# Report on Review of Bay Delta Conservation Program Modeling

Since December 2012, MBK Engineers and Dan Steiner (collectively “Reviewers”) have assisted various parties in evaluating the operations modeling that was performed for the Bay Delta Conservation Plan (BDCP). To assist in understanding BDCP and the potential implications, stakeholders<sup>1</sup> requested that the Reviewers review the CalSim II modeling studies performed as part of the BDCP (hereafter “BDCP Studies” or “BDCP Model”).

Figure 2. Projected Shasta Reservoir Carryover Storage, NAA, NAA-ELT and NAA-LLT

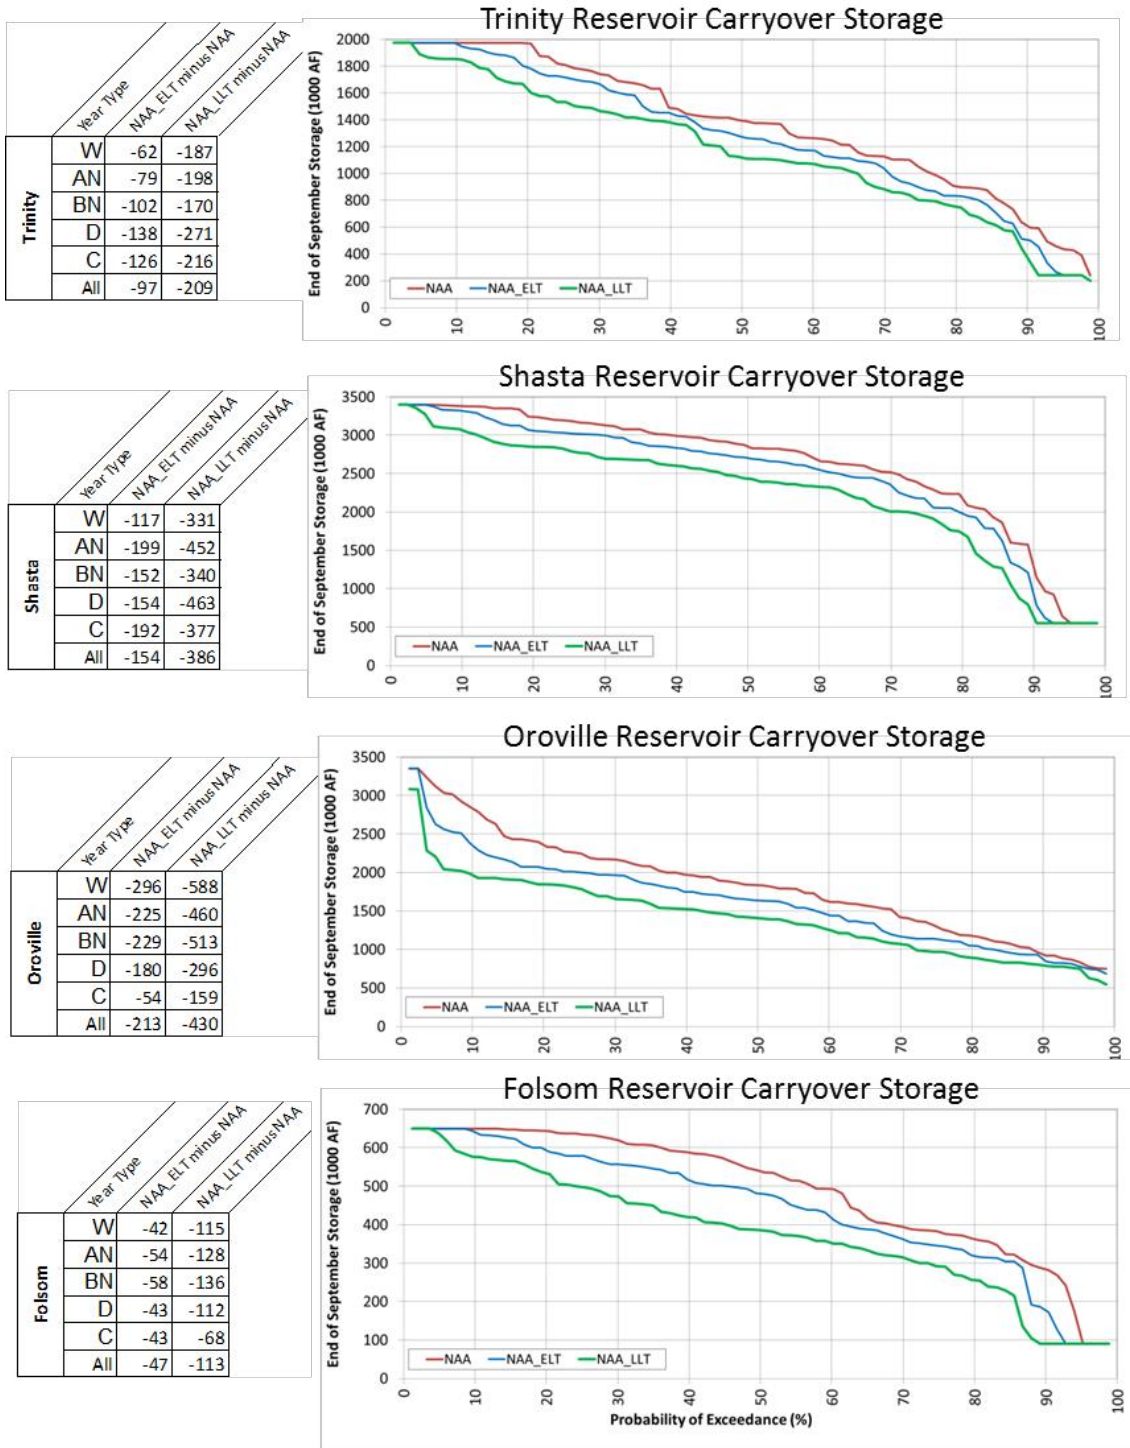
For upstream CVP and SWP reservoirs the assumed shift of inflows due to climate change (Figure 1) along with a continuing need to satisfy exports demands significantly affects carryover storage. The CVP and SWP simply cannot satisfy water demands and regulatory criteria imposed on them in the NAA-ELT and NAA-LLT modeling scenarios.

Figure 2 illustrates the typical change in carryover storage as shown for Trinity, Shasta, Oroville, and Folsom Reservoirs. The relatively high frequency (approximately 10% of time) of minimum storage occurring at CVP reservoirs illustrates our questioning of credible operations in the studies.

**Figure 3. Projected Inflow to Millerton Lake –NAA, NAA-ELT and NAA-LLT**

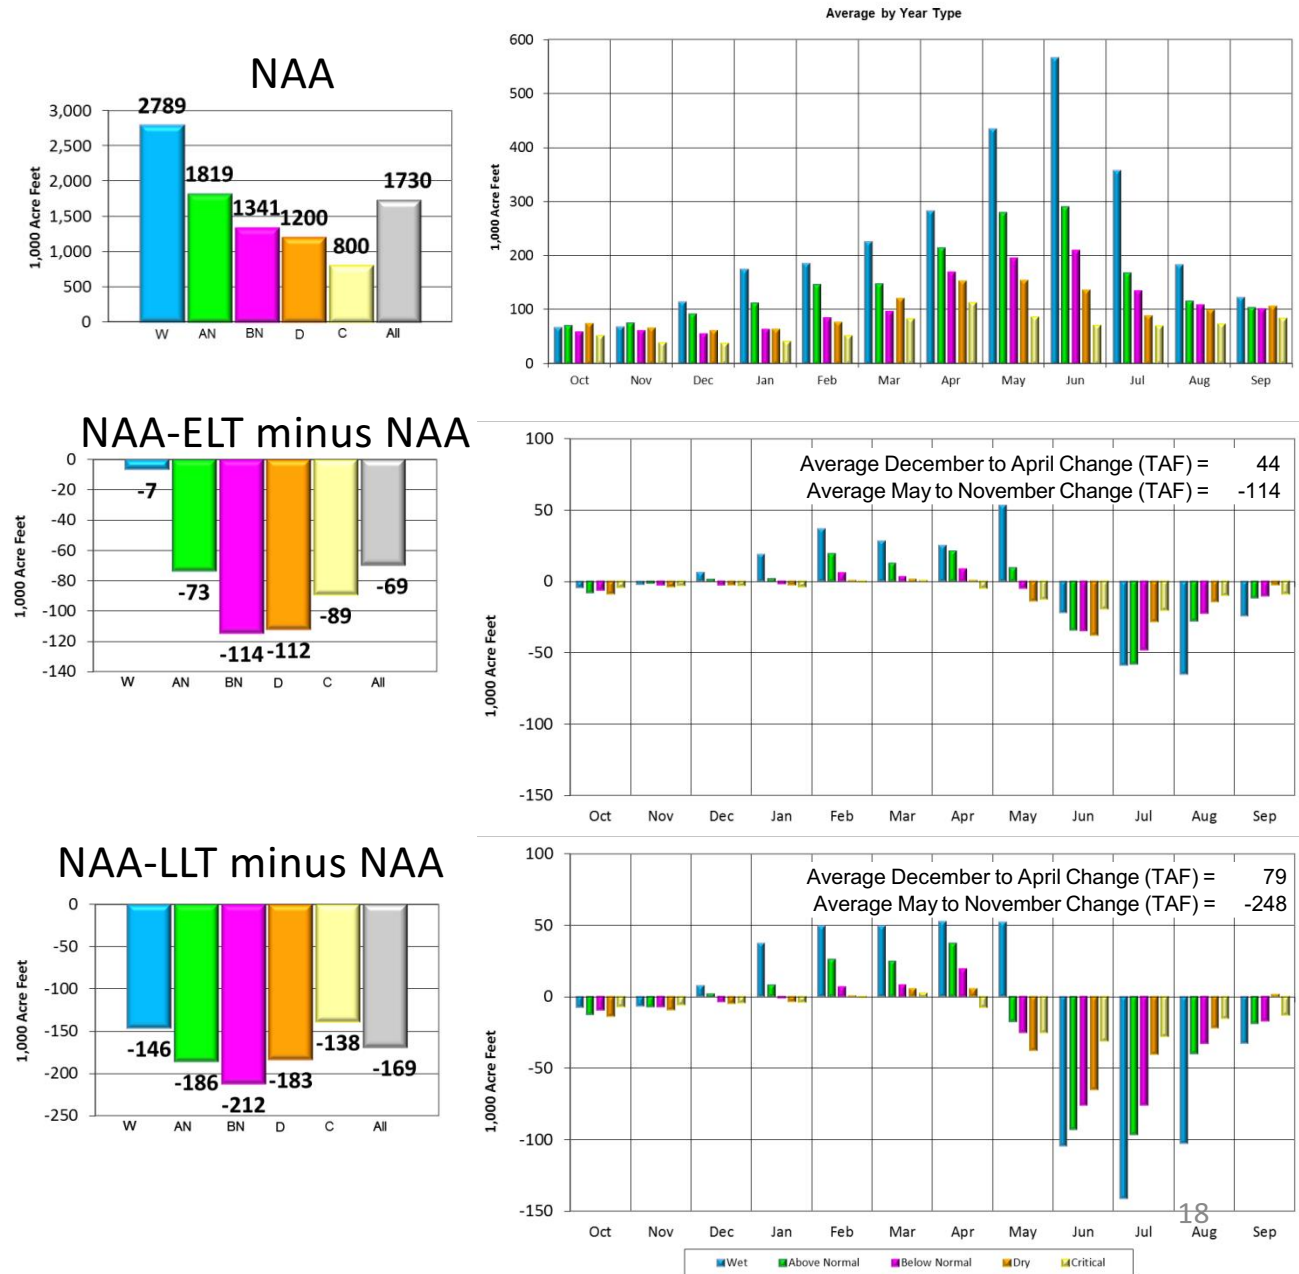
The hydrology differences imposed in the NAA Scenarios of the Friant Division are described above, and its appropriateness may be subject to additional debate and Alternative assumptions. However, our review found that implementation of Millerton Reservoir inflow as affected by climate change was improperly performed.

Inflow to Millerton Reservoir in this version of CalSim is input in three separate time series for purposes of depicting the hydrology of potential upper basin reservoirs. Climate change hydrology was inconsistently incorporated at Millerton Reservoir and misapplied to the water supply and flood control operations. The result is an unrealistic operation for river releases and canal diversions. Figure 3 illustrates the projected ELT and LLT changes in Millerton Reservoir inflow incorporated in these studies. On face value of the input data, regardless of Friant Dam river release assumptions the effect of climate change at Millerton Lake will affect water deliveries.

**Figure 4. Millerton Reservoir Carryover Storage, NAA, NAA-ELT and NAA-LLT Scenarios**

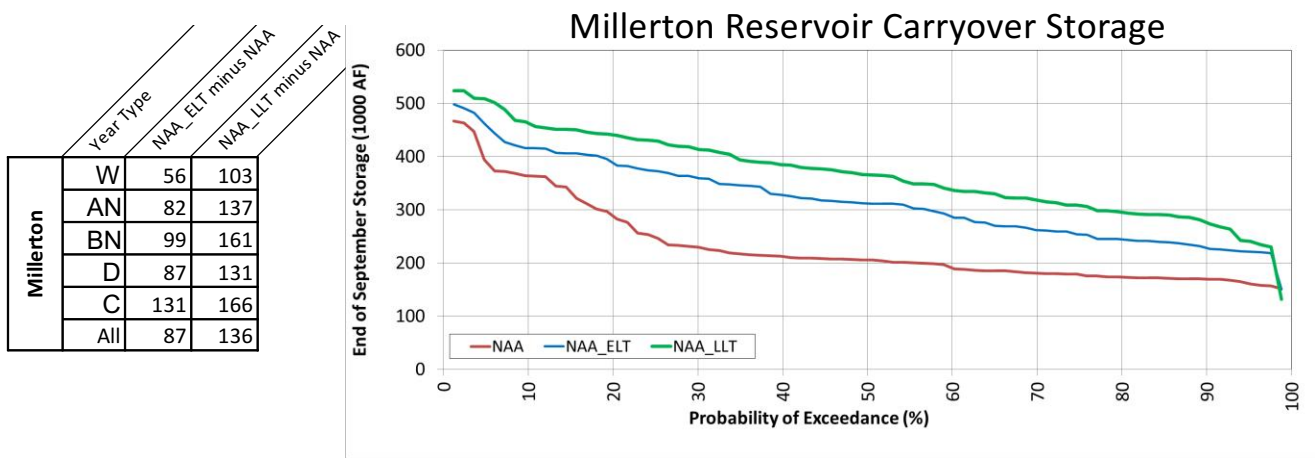
Evidence of the inconsistent inflow problem is shown in the result for the comparison of carryover storage of Millerton Reservoir under the NAA, NAA-ELT, and NAA-LLT Scenarios (Figure 4). Carryover storage is higher in the ELT and LLT Scenarios due to climate change effects to inflow incorporated in reservoir operations but not in the computation of water supply deliveries. Thus, water deliveries are suppressed and the reservoir ends the year with greater storage.

**Figure 12. Temperature Exceedance Sacramento River at Bend Bridge Existing, No Action Alternative, ELT**

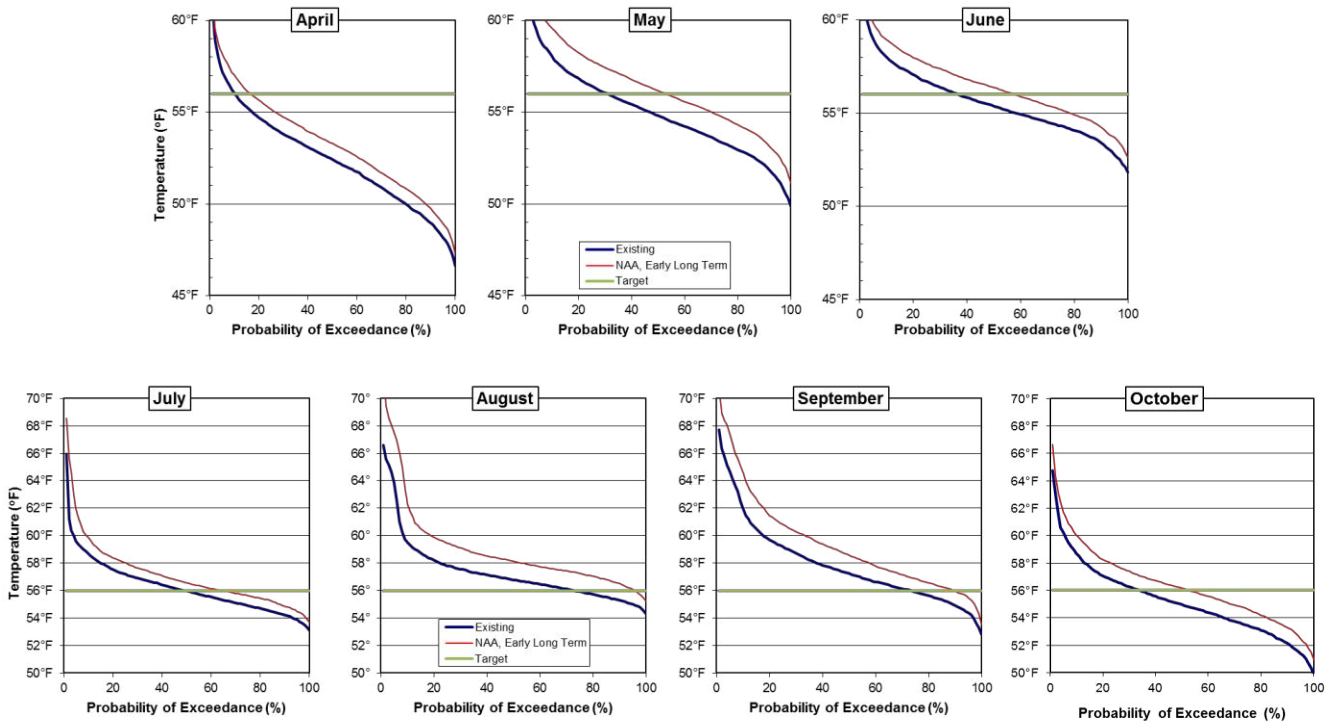
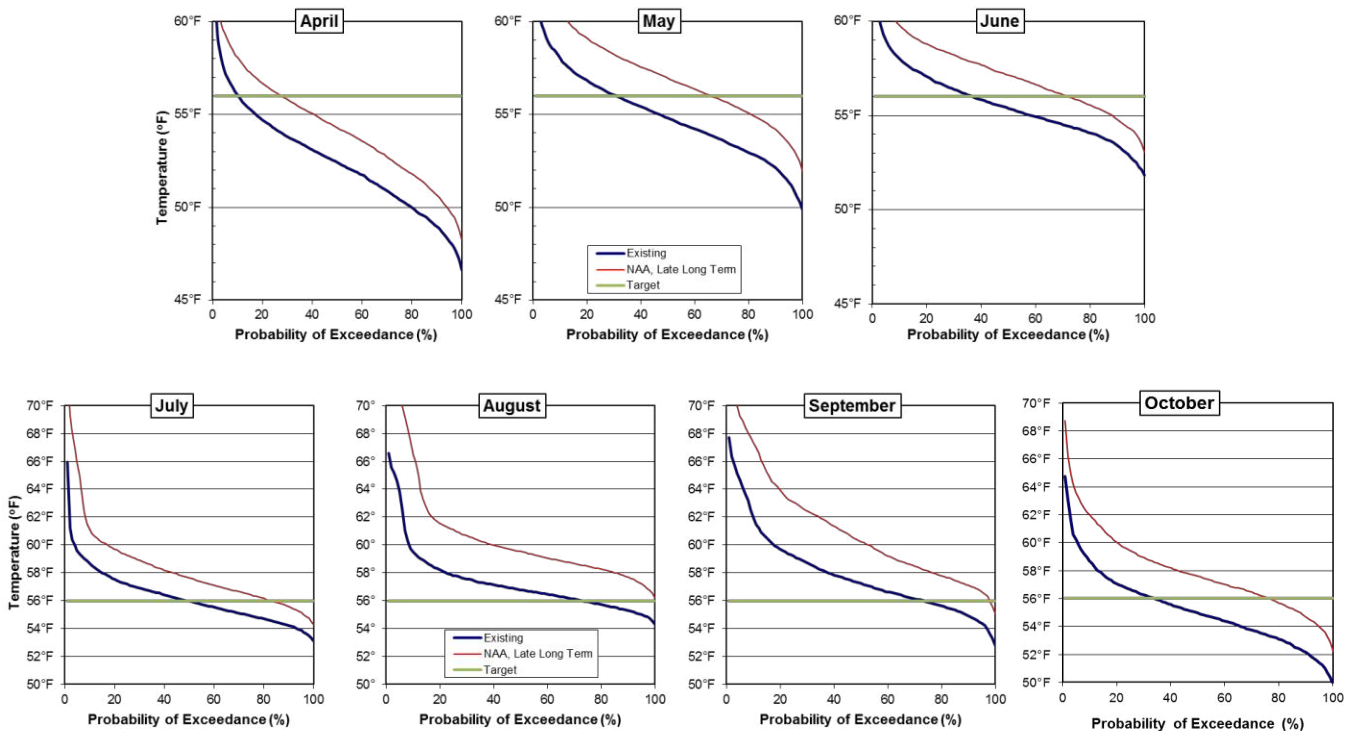
The increase in equilibrium temperatures combined with decreases in storage would lead to water temperature conditions that would likely not achieve the assumed objectives. Figure 12 and Figure 13 illustrate an increase in the probability that a water temperature target of 56°F would be exceeded at Bend Bridge under both the NAA-ELT and NAA-LLT Scenarios. The probability of exceedance increases approximately 5% to 20% depending on the month for the NAA-ELT Scenario and approximately 10% to 40% for the NAA-LLT Scenario.

Figure 19. NDD, Bypass Requirement, Bypass Flow, and Excess Sacramento R. flow for Alt 4-ELT

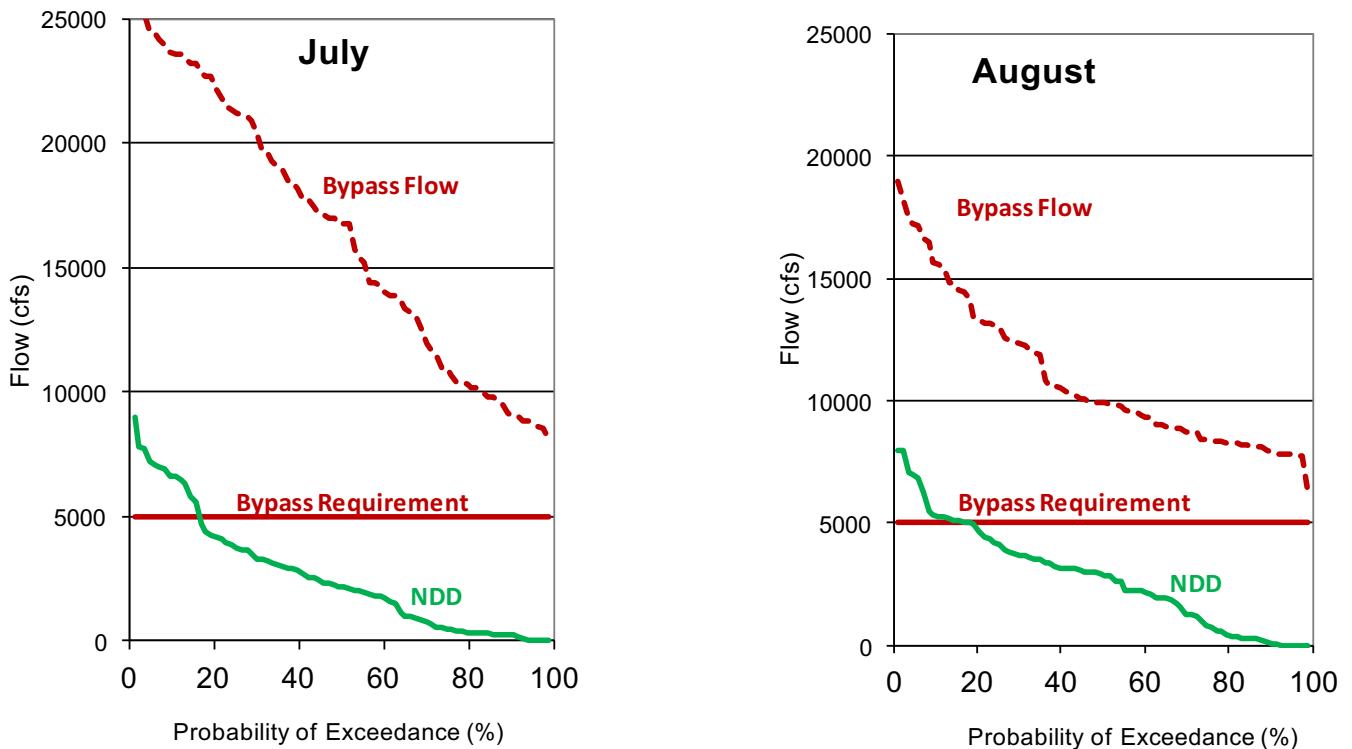
Sacramento River flow below the North Delta Diversion (NDD) must be maintained above the specified bypass flow requirement, therefore the NDD rates are limited to the Sacramento River flow above the bypass requirement. Due to an error in CalSim II that specifies an unintended additional bypass requirement, modeling performed for the BDCP EIRS often bypasses more Sacramento River flow than is specified in the BDCP project description. This error has been fixed in the most recent public releases of CalSim II, but BDCP modeling has not been updated to reflect these fixes. Figure 19 contains exceedance probability plots showing the Sacramento River required bypass, Sacramento River bypass flow, NDD, and excess Sacramento River flow to the Delta as modeling for BDCP. As can be seen in Figure 19, the bypass flow is always above the bypass requirement in July and August. The BDCP version of CalSim sets a requirement for Sacramento River inflow to the Delta needed to satisfy all Delta flow, quality, and export requirements, this requirement should be removed when modeling the NDD.

Figure 22. Alt 4-ELT North Delta Diversion Versus South Delta Diversion for July, August, and September

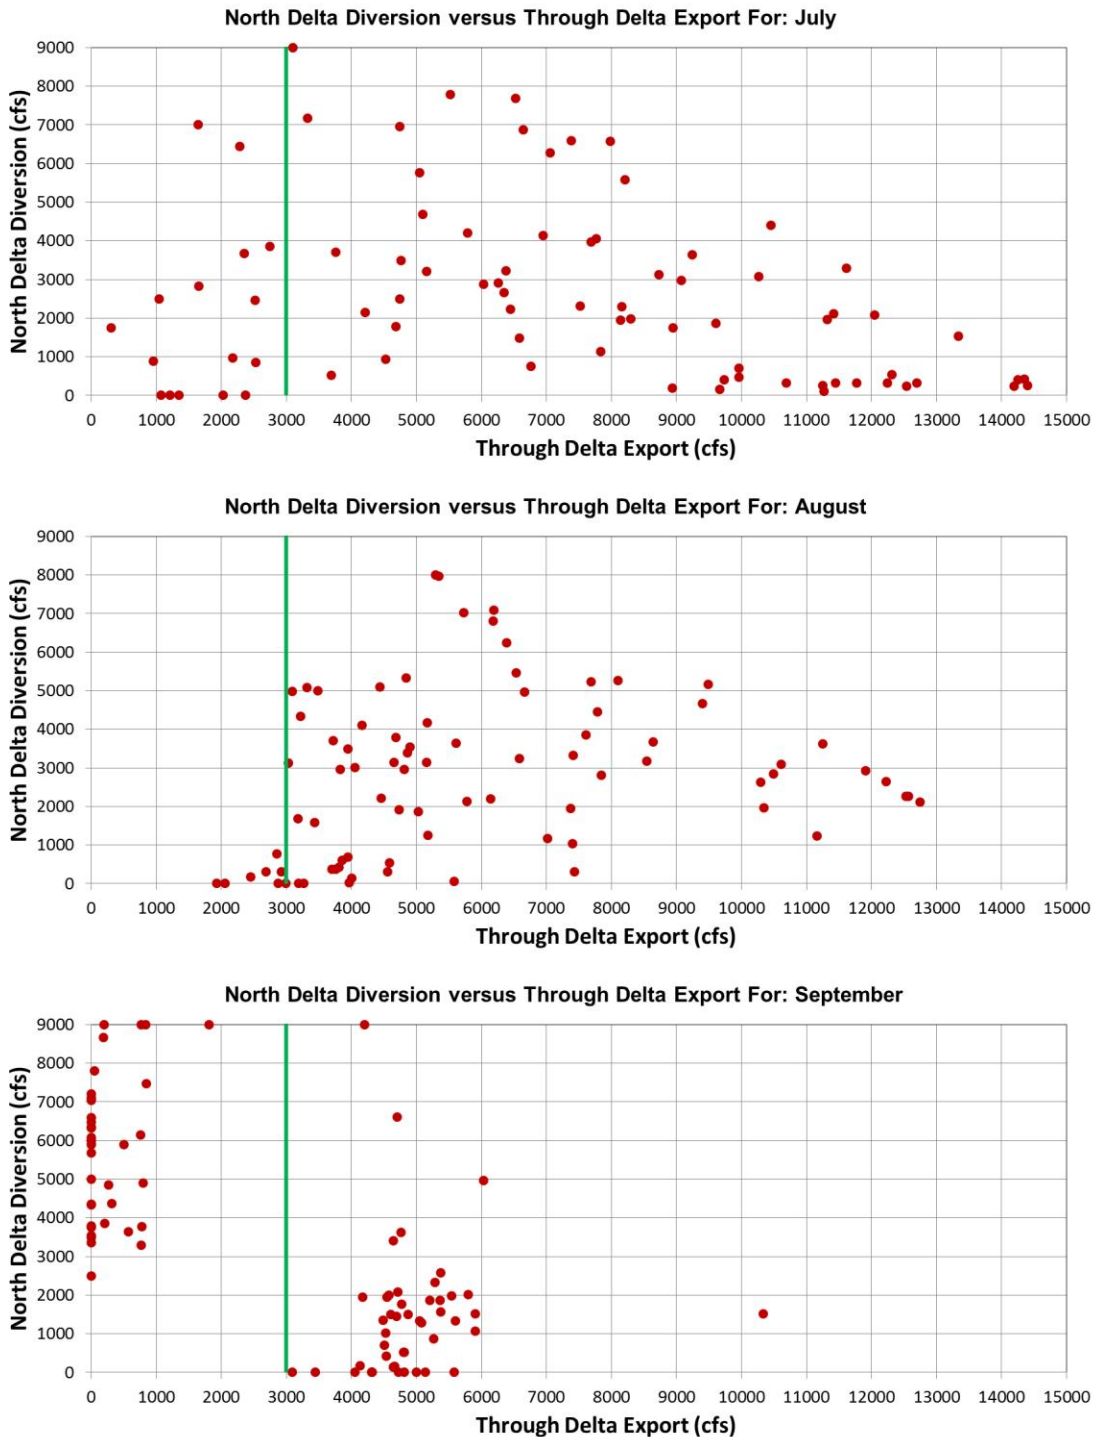
Figure 22 contains figures for July, August, and September for Alt 4-ELT that plot NDD against SDD. In the months of July to September SDD are occasionally very high, exceeding 14,000 cfs in July, with minimal NDD. This occurs due to outdated model code that imposes an instream flow requirement in Sacramento River flow below Hood in excess of the bypass criteria prescribed in the BDCP. There are numerous occurrences when bypass flows prescribed in the BDCP are exceeded and SDD are higher than expected. On the other hand, there are also many times when NDD are above minimum pumping levels and SDD are below the BDCP prescribed 3,000 cfs threshold indicated by the green line in Figure 22. For unknown reasons, the model code requiring SDD to be greater than 3,000 cfs before NDDs occur from July through September is deactivated in the BDCP modeling of this Alternative.

Figure 23. South Delta Diversion at Banks

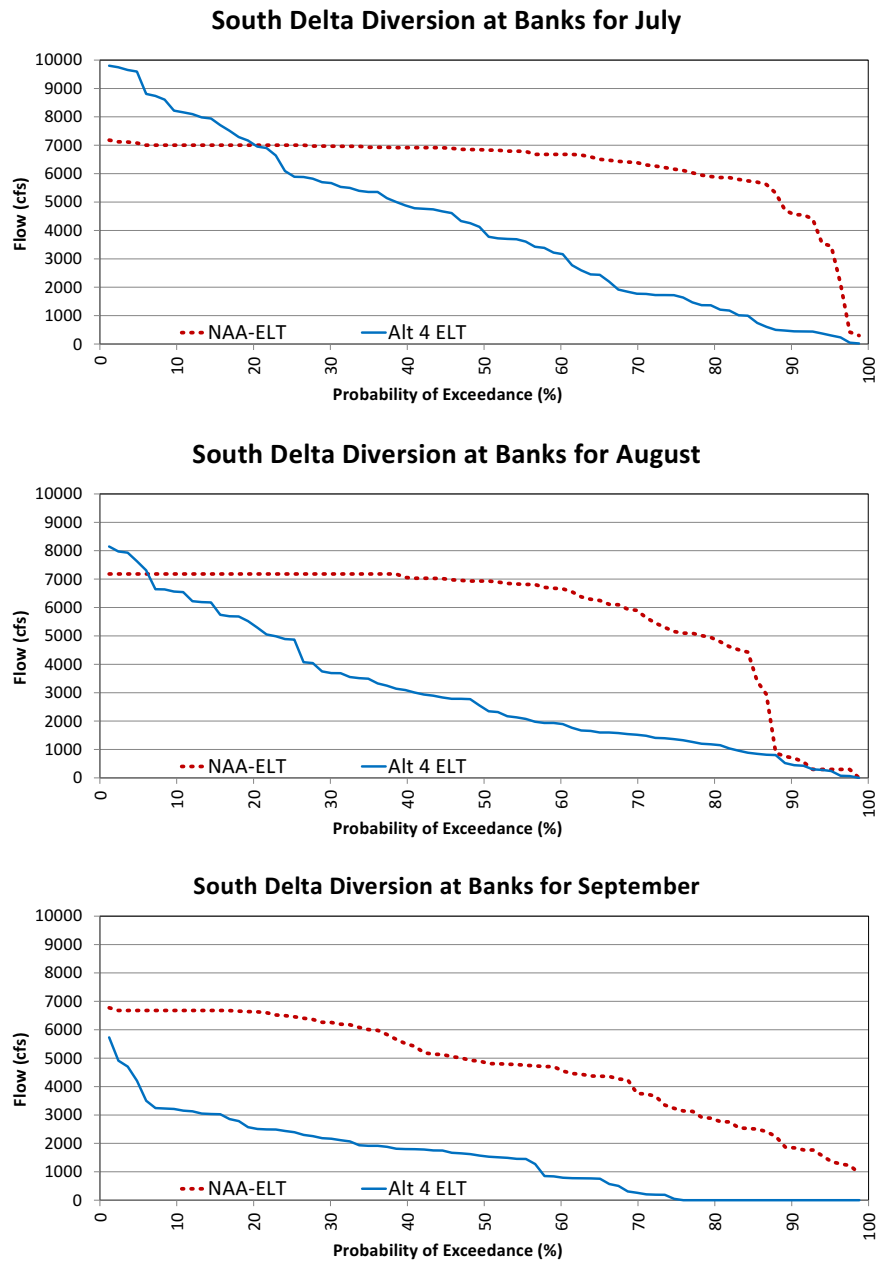
South Delta Diversion at Banks is not limited to existing permit capacity of 6,680 cfs and pumping may reach full capacity of 10,300 cfs in July, August, and September. Figure 23 contains exceedance probability charts of South Delta Diversion at Banks for July, August, and September. The chart for July shows SDD at Banks exceeding existing permit capacity 20% of years, in August this occurs in about 7% of years. There are South Delta diversions at Banks 25% of the time in September while diversions from the Sacramento River may range from 2,500 cfs to 7,500 cfs.
